Product Change Notification / LIAL-24KOXB344

CCB 4477 Final Notice Implement additional cover tape, carrier tape and plastic reel material supplier for selected Micrel products available in 3L, 5L, 6L and 8L SOT23, 5L and 6L TSOP and 8L SOIC packages at STAR assembly site.

Carrier Tape for SOT23-3/5/6/8L , TSOT-5L/6L

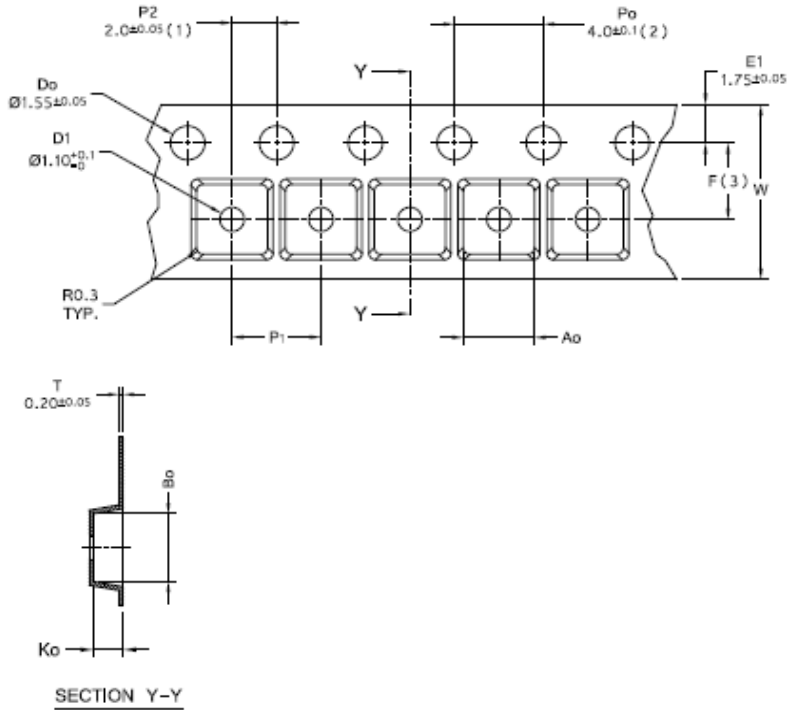
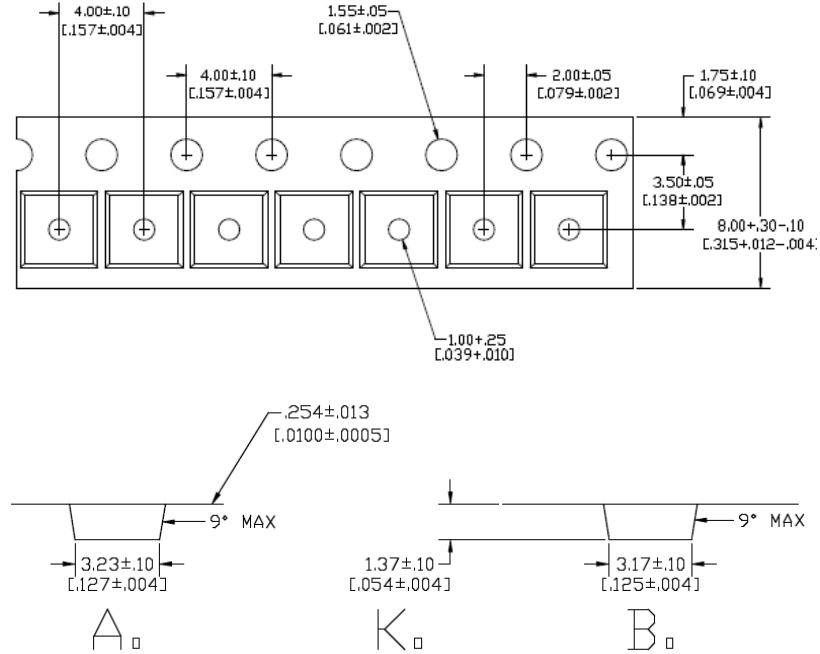
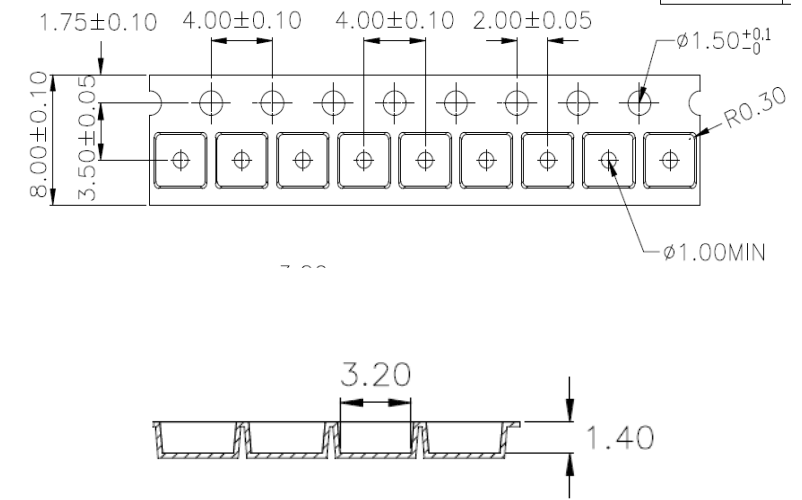
Carrier Tape Supplier	Supplier Mfg. part no.	Width (mm)	Pitch (mm)	A0 (mm)	B0 (mm)	K0 (mm)	Thickness (mm)
CPAK	CP197	8.00 ±0.100	4.00 ±0.100	3.20 ±0.10	3.20 ±0.10	1.40 ±0.10	0.20 ±0.05
3M	0A85CARR SOT23	8.00 +0.30/-0.10	4.00 ±0.100	3.23 ±0.10	3.170 ±0.10	1.370 ±0.10	0.254 ±0.013
U-PAK	SMSC323214	8.00 ±0.100	4.00 ±0.100	3.20 ±0.10	3.20 ±0.10	1.40 ±0.10	0.20 ±0.05

Cover Tape for SOT23-3/5/6/8L , TSOT-5L/6L

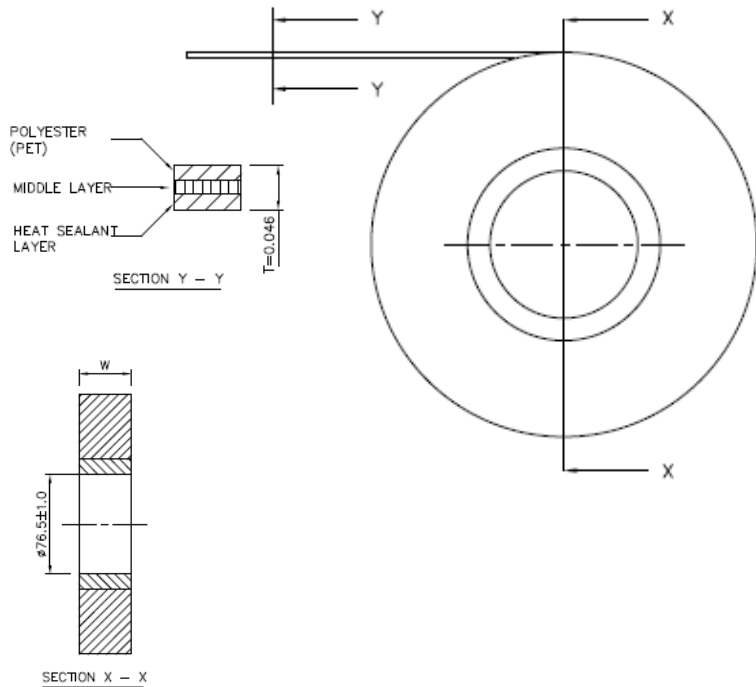
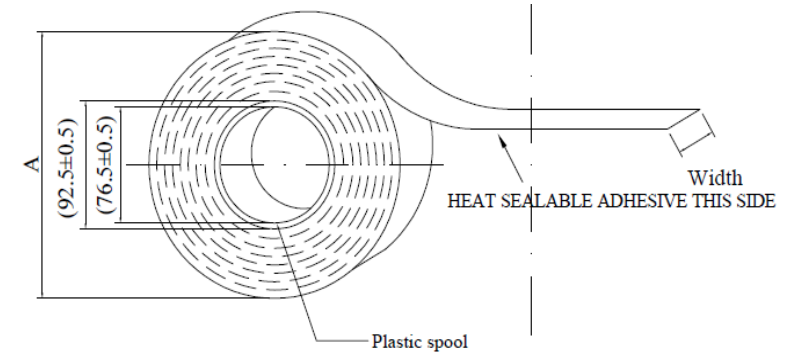
Supplier	Supplier Mfg. part no.	Carrier width (mm)	Cover tape Width "W" (mm)	Thickness (mm)	Sealing Methodology
CPAK	CP38-054A, 5.4 mm	8.4	5.4 ± 0.1 mm	0.055 ± 0.01mm	Heat Seal
3M	2675, 5.4 mm	8.4	5.4 ± 0.1 mm	0.062 ± 0.013mm	Heat Seal
U-PAK	UP-175-054	8.4	5.4 ± 0.1 mm	0.048 ± 0.050mm	Heat Seal

Plastic Reel 7 inch for SOT23-3/5/6/8L , TSOT-5L/6L

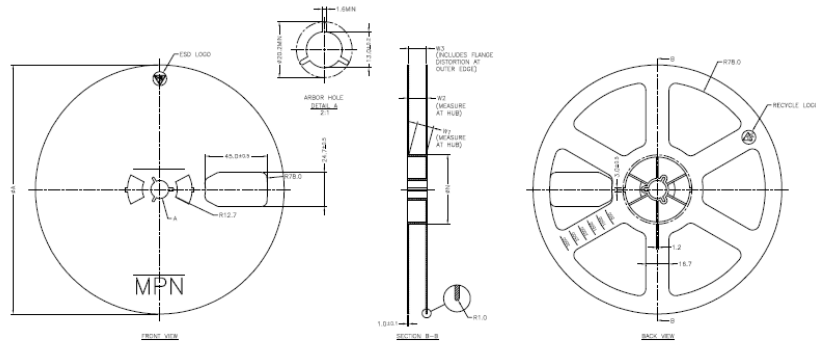
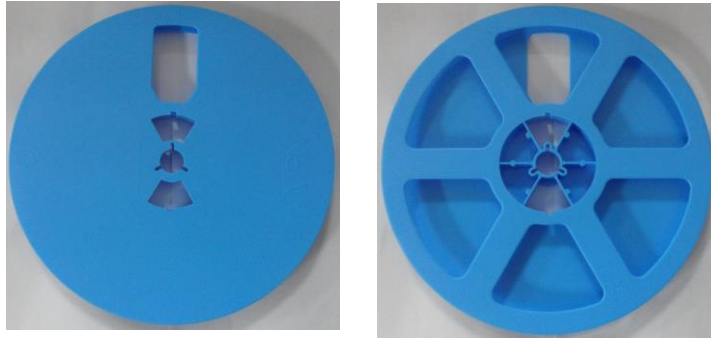
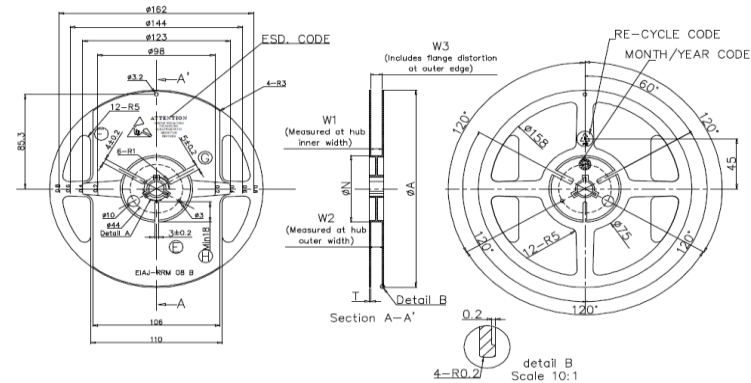
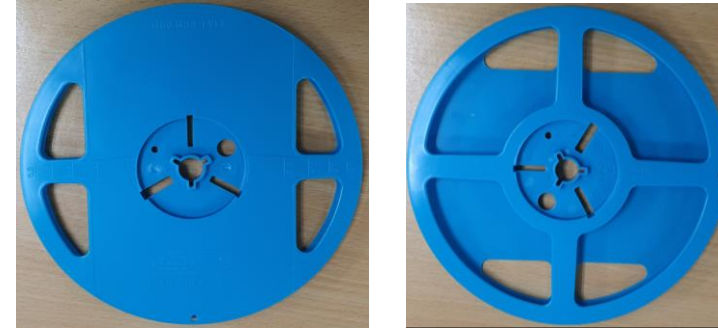
Supplier	Carrier Tape Width (W1)	Diameter (ΦA)	Hub (ΦN)	Color
CPAK	8.4 +1.5/-0 mm	180 mm max	50mm min	Blue shade
LPP	8.4 +1.5/-0 mm	172 ± 2.0 mm	60.5 ± 0.50mm	Blue shade

Carrier Tape for SOIC8L

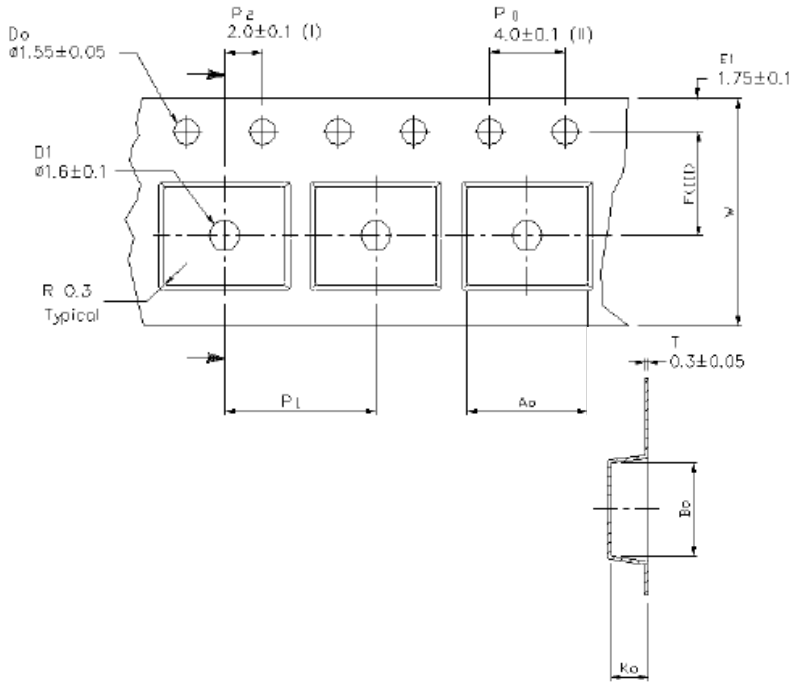
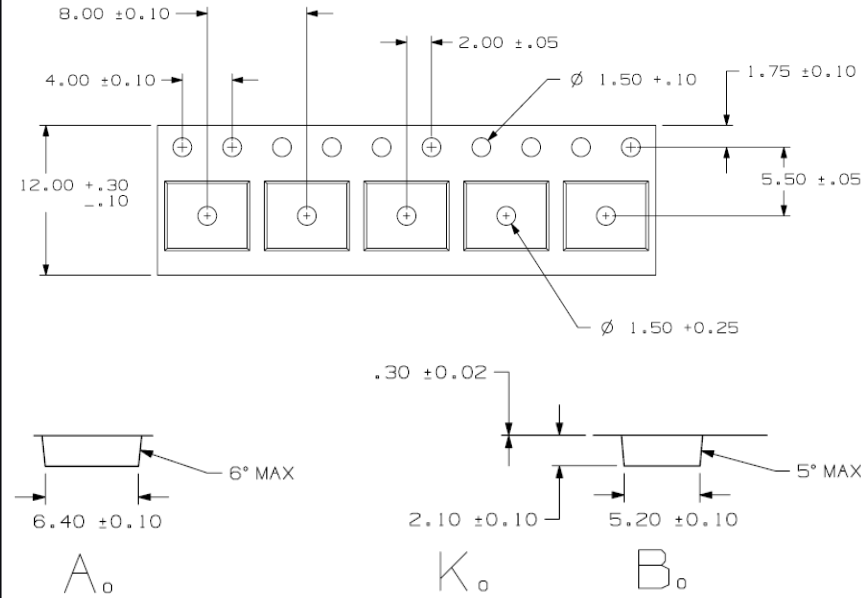
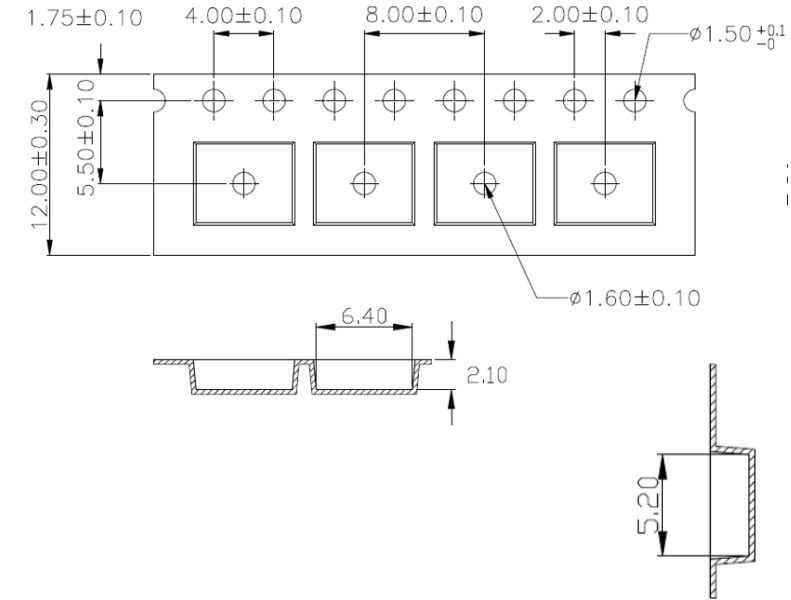
Carrier Tape Supplier	Supplier Mfg. part no.	Width (mm)	Pitch (mm)	A0 (mm)	B0 (mm)	K0 (mm)	Thickness (mm)
CPAK	CPD-092A	12.00 ± 0.100	8.00 ± 0.100	6.40 ± 0.10	5.20 ± 0.10	2.10 ± 0.10	0.30 ± 0.05
3M	TWO13611-4	$12.00 + 0.30 / - 0.10$	8.00 ± 0.100	6.40 ± 0.10	5.20 ± 0.10	2.10 ± 0.10	0.30 ± 0.02
U-PAK	UPKSOIC08A-SMS	12.00 ± 0.100	8.00 ± 0.100	6.40 ± 0.10	5.20 ± 0.10	2.10 ± 0.10	0.30 ± 0.05

Cover Tape for SOIC8L

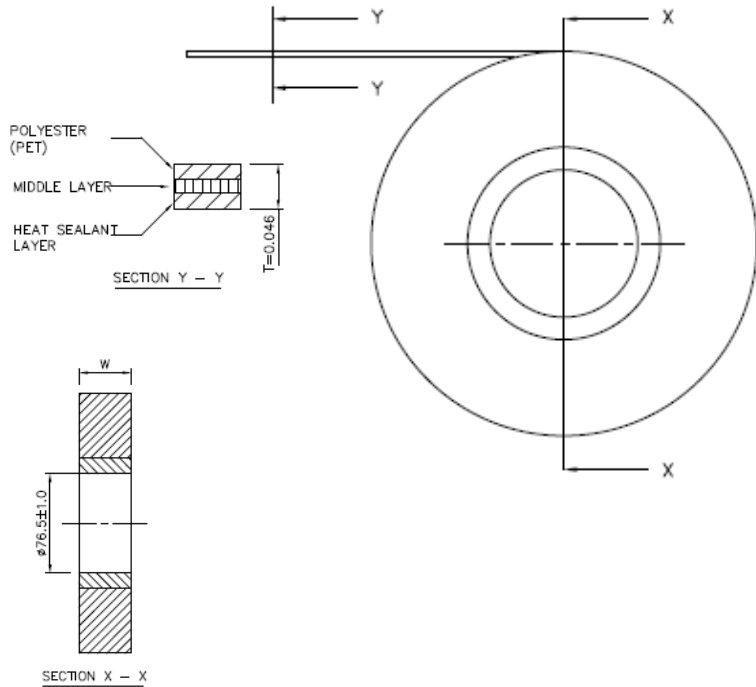
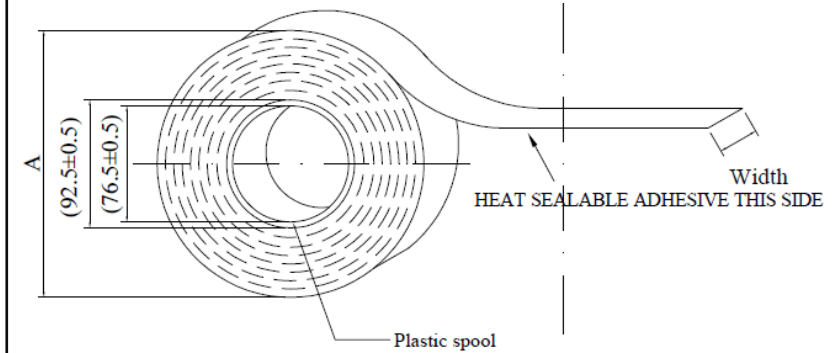
Supplier	Supplier Mfg. part no.	Carrier width (mm)	Cover tape Width "W" (mm)	Thickness (mm)	Sealing Methodology
CPAK	CP38-054A, 5.4 mm	12	9.2 ± 0.1 mm	0.056 ± 0.005mm	Heat Seal
3M	2675, 9.3 mm	12	9.3 ± 0.1 mm	0.062 ± 0.013mm	Heat Seal
U-PAK	UP-175-093	12	9.3 ± 0.1 mm	0.048 ± 0.050mm	Heat Seal
